**Subject: Response to Portion of NRC Request for Additional Information
Letter No. 40 Related to ESBWR Design Certification Application –
ESBWR Probabilistic Risk Assessment – RAI Numbers 19.1-8,
19.1-17, 19.2-6, 19.2-10, 19.2-13 and 19.2-18**

Response to Portion of NRC Request for
Additional Information Letter No. 40
Related to ESBWR Design Certification Application
ESBWR Probabilistic Risk Assessment
RAI Numbers 19.1-8, 19.1-17, 19.2-6, 19.2-10,
19.2-13 and 19.2-18

Figure 6.2-28. Vacuum Breaker Design Features

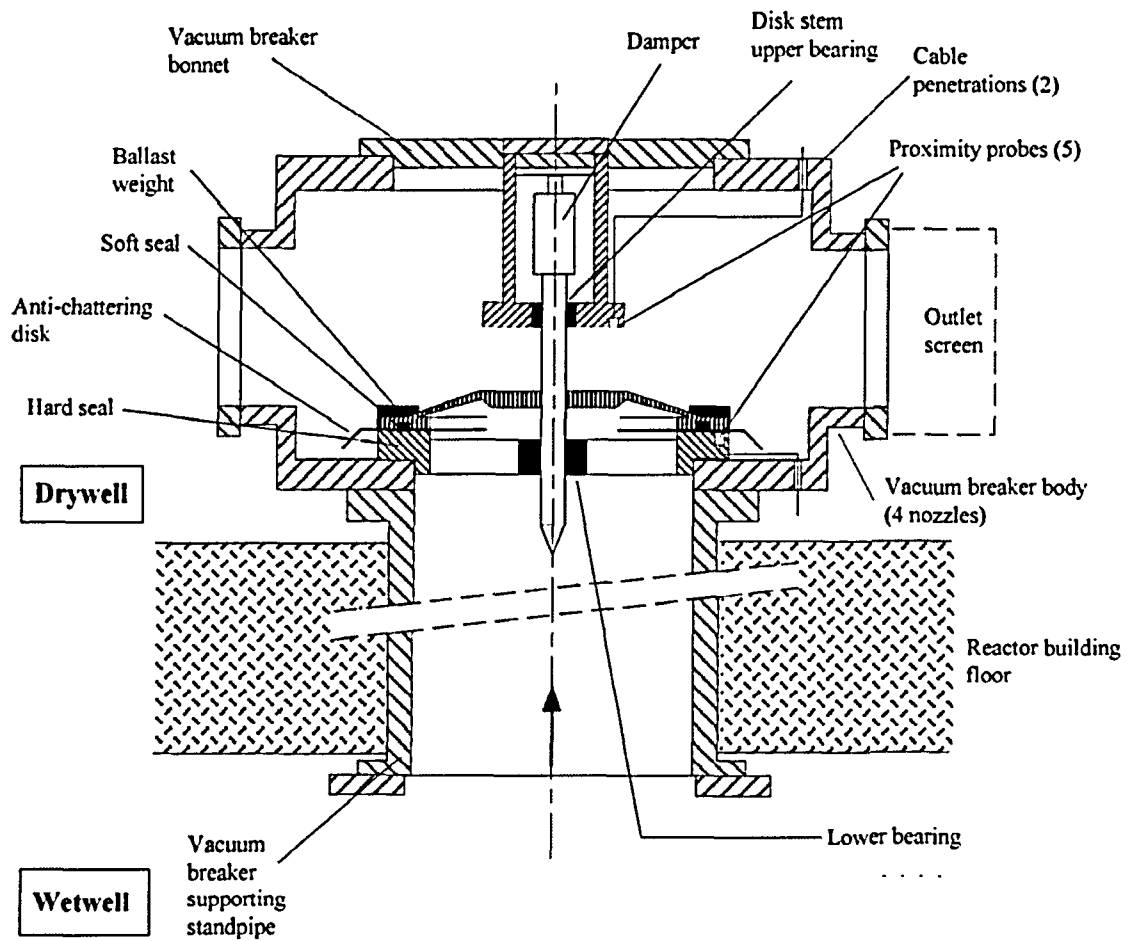
Provide additional information regarding the drywell to suppression chamber vacuum breakers, including drawings showing the vacuum breaker, proximity/position sensors, and DC motor-operated valve that would provide isolation if the vacuum breaker sticks open or leaks in its closed position (as described in Section 4.18.3.1 of the PRA).

DCD Section 6.2.1.1.2, fifth paragraph under the heading "Drywell" provides description of the drywell-to wetwell vacuum breaker and the upstream isolation valve. This paragraph will be revised to read as follows:

"Vacuum breakers are provided between the DW and WW. The vacuum breaker is self-actuating valve, similar to a check valve. The purpose of the DW-to-WW vacuum breaker system is to protect the integrity of the diaphragm floor slab and vent wall between the DW and the WW, and the DW structure and liner, and to prevent back-flooding of the suppression pool water into the DW. The vacuum breaker is provided with redundant proximity sensors to detect its closed position. On the upstream side of the vacuum breaker, a DC solenoid operated ~~butterfly~~ isolation valve designed to fail-close is provided. The vacuum breaker is illustrated in Figure 6.2-28. During a LOCA, when the vacuum breaker opens and allows the flow of gas from WW to DW to equalize the DW and WW pressure and subsequently does not completely close as detected by the proximity sensors, a control signal will close the upstream ~~butterfly~~ isolation valve to prevent extra bypass leakage due to the opening created by the vacuum breaker and therefore maintain the pressure suppression capability of the containment. Redundant vacuum breaker systems are provided to protect against a single failure of vacuum breaker, i.e., failure to open or failure to close when required. The design DW-to-WW pressure difference and the vacuum breaker full open differential pressure is given in Table 6.2-1."

Figure 6.2-28 shown below will be added in DCD Tier 2.
